EXHIBIT B (Page 1 of 7)

PRIMARY CONTAINMENT ISOLATION

3.0 LIMITING CONDITIONS FOR OPERATION

FIGURE 3.7.1

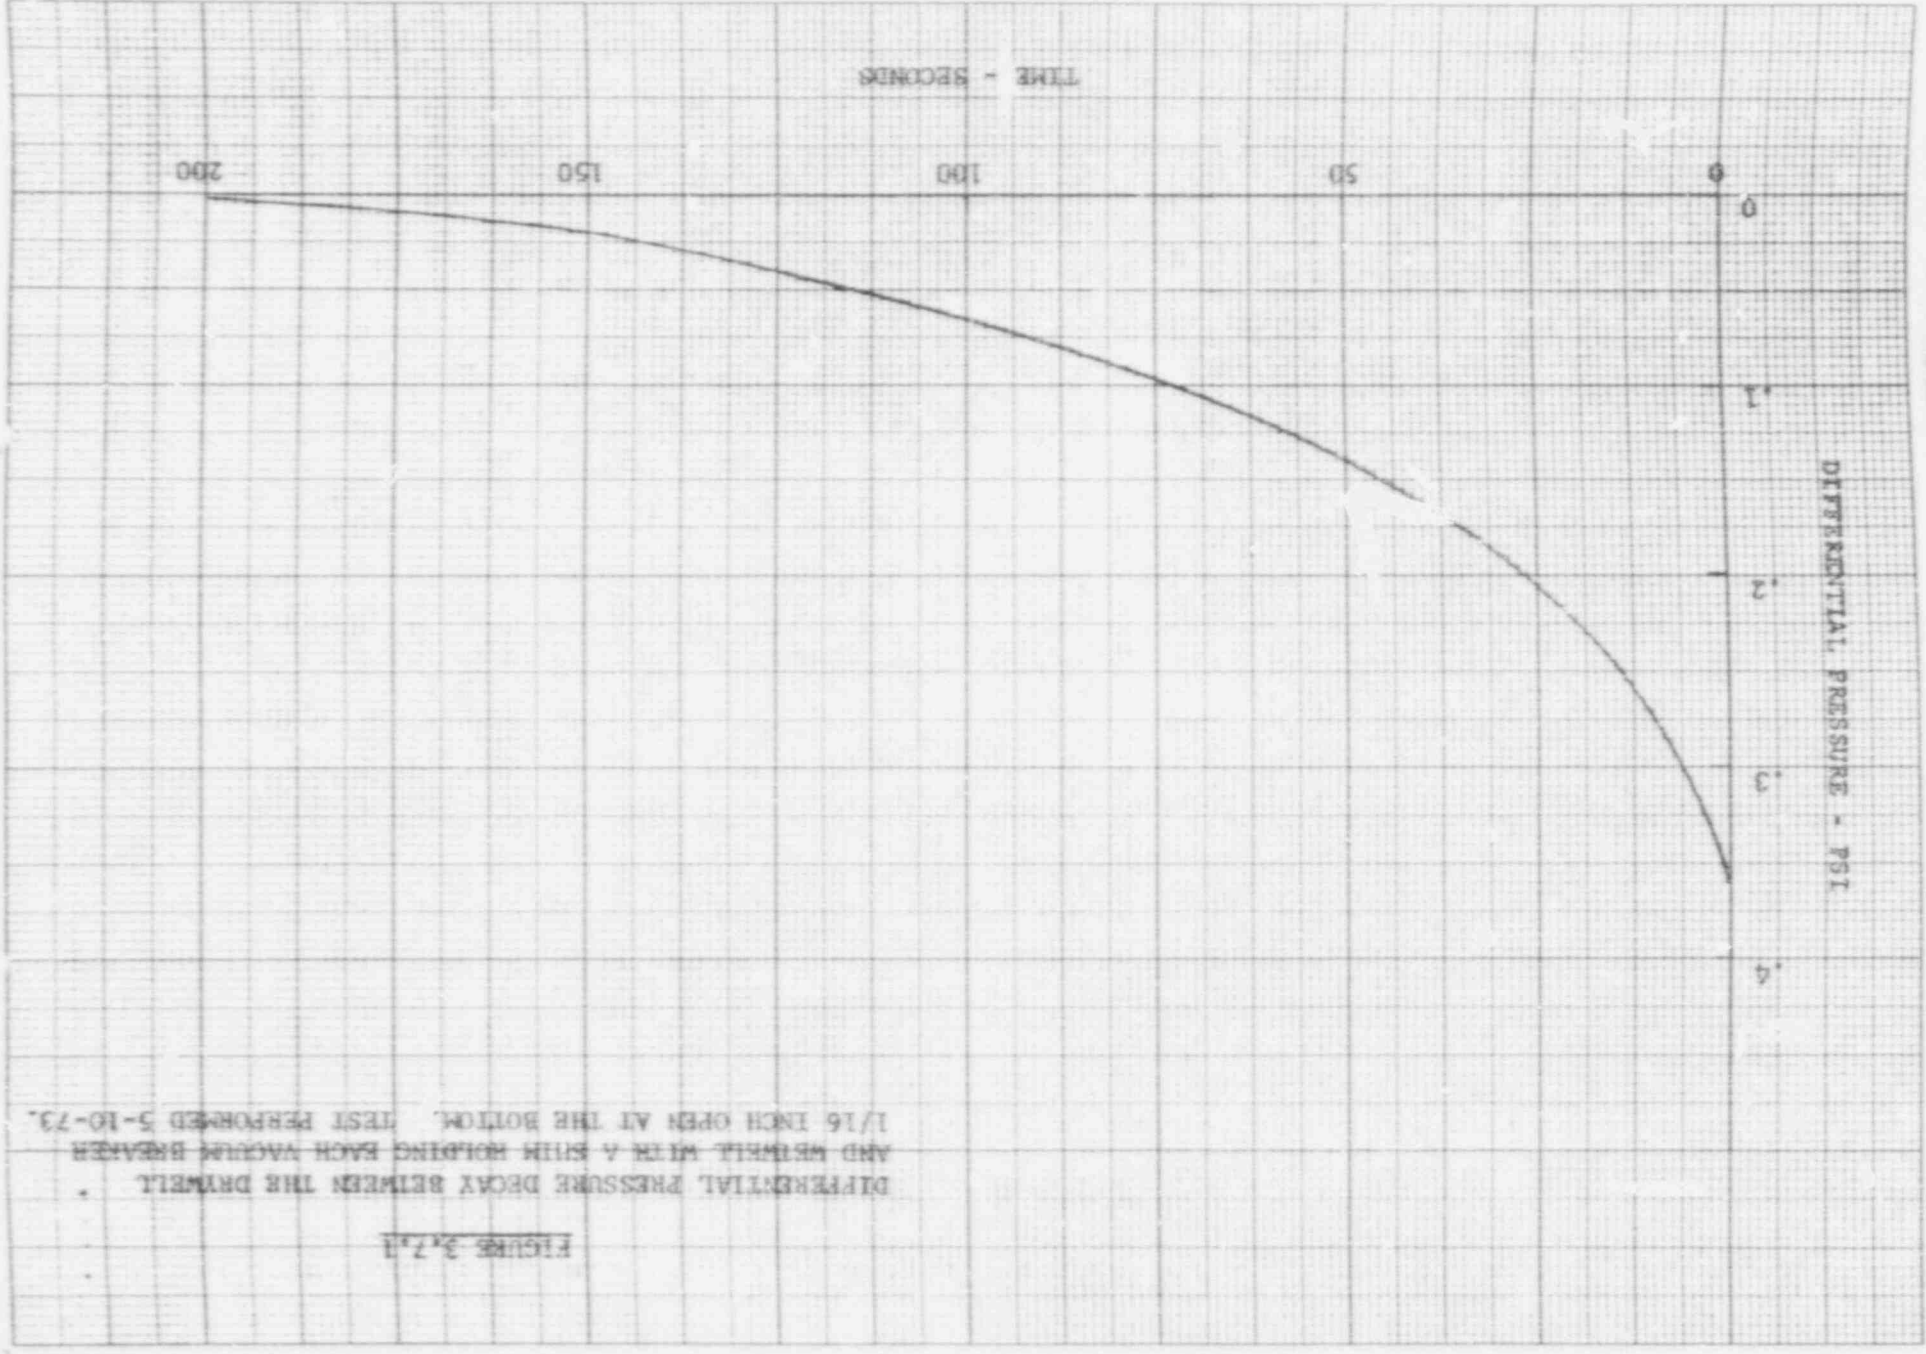
- b. Any drywell-suppression chamber vacuum breaker may be nonfully closed as indicated by the position indication system provided that drywell to suppression chamber differential pressure decay does not exceed that shown on Figure 3.7.1.

- c. Up to two drywell-suppression chamber vacuum breakers may be inoperable provided that: (1) the vacuum breakers is determined to be fully closed as indicated by the position indication system or if drywell to suppression chamber differential pressure decay does not exceed that shown on Figure 3.7.1 or (2) the vacuum breaker is secured in the closed position.

- b. When the position of any drywell-suppression chamber vacuum breaker valve is indicated to be not fully closed at a time when such closure is required, the drywell to suppression chamber differential pressure decay shall be demonstrated to be less than that shown on Figure 3.7.1 immediately and following any evidence of subsequent operation of the inoperable valve until the inoperable valve is restored to a normal condition.
